UTAH VALLEY UNIVERSITY
SITE LIGHTING UPGRADE

To:	Fred Christensen
From:	Ryan Van Voast, EE
CC:	Brent Halladay; Mike Ambre; Stephen Hewlett
Date:	October 13, 2008
Re:	UVU site lighting upgrade plan review comments

UVU site lighting plan review comments:

EL601

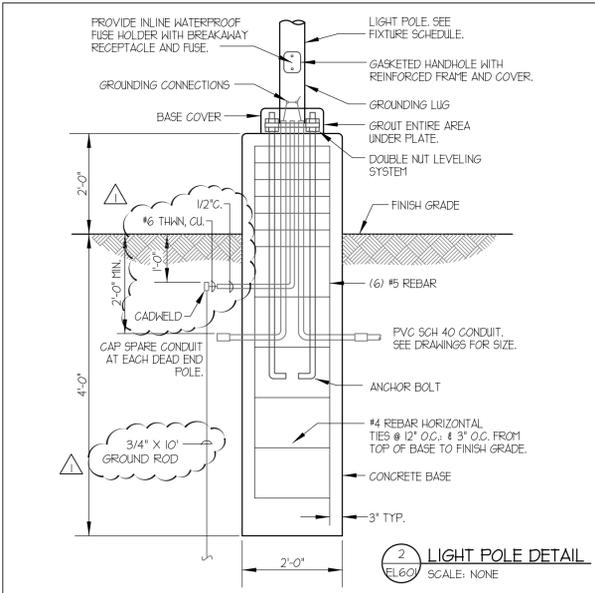
1. Detail 2 on sheet EL601 indicates that the light poles are to be provided with a grounding system. Please provide the size of the grounding conductor and ground rod.

Provide a # 6 THWN CU Conductor cad welded to a 3/4 inch by 10' ground rod.
Refer to the attached ESD for more information.
